Product Change Notification

PCN-MI-2273-2018

Business Unit	Product Line Code	Type of Change	Action	Date of Issue
MI - Marking and Installation	BG4	Product Change Notification	Notify Distributors and Field	8/21/2018

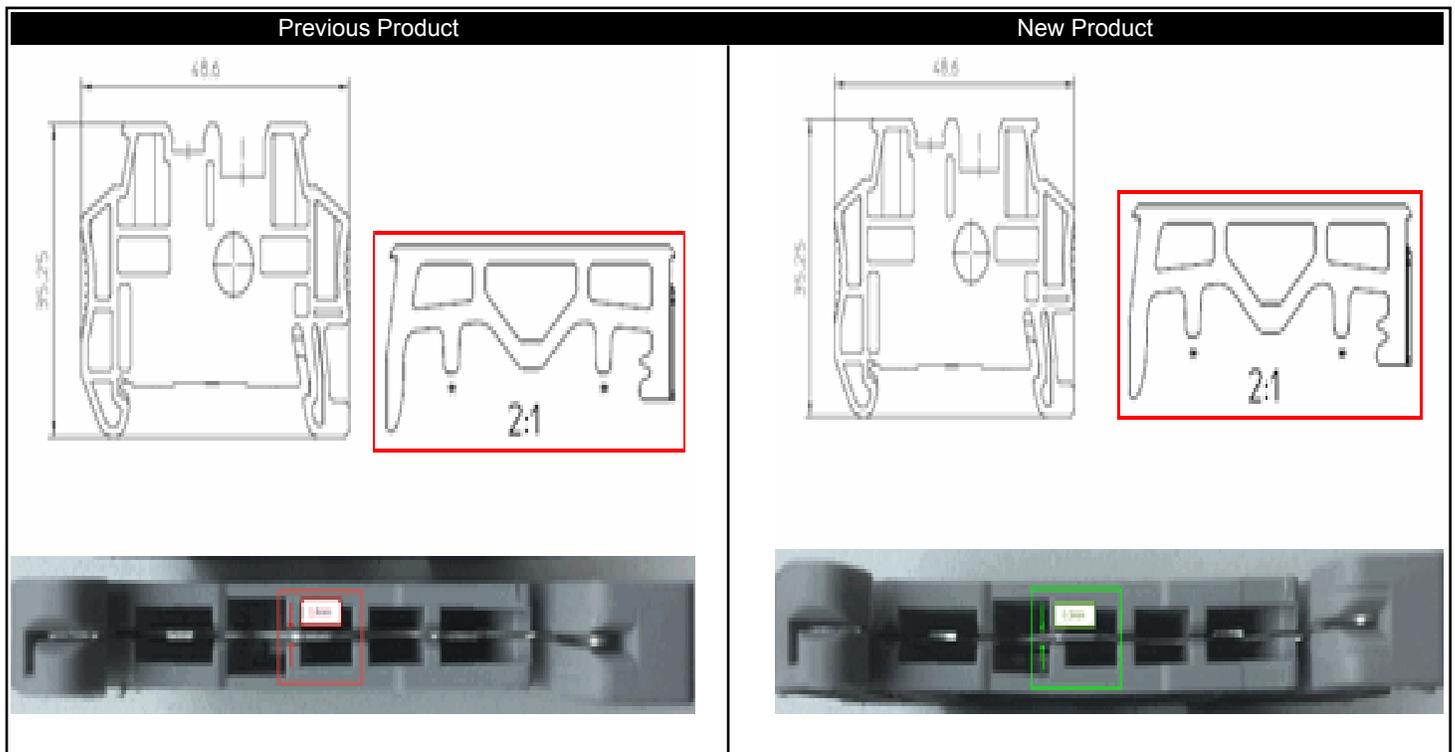
Reduction of the thickness of the metal part from 0,4 down to 0,3 mm. Due to this change the end bracket can be mounted and removed more comfortable. A proper fixation on the DIN-rail is still given.
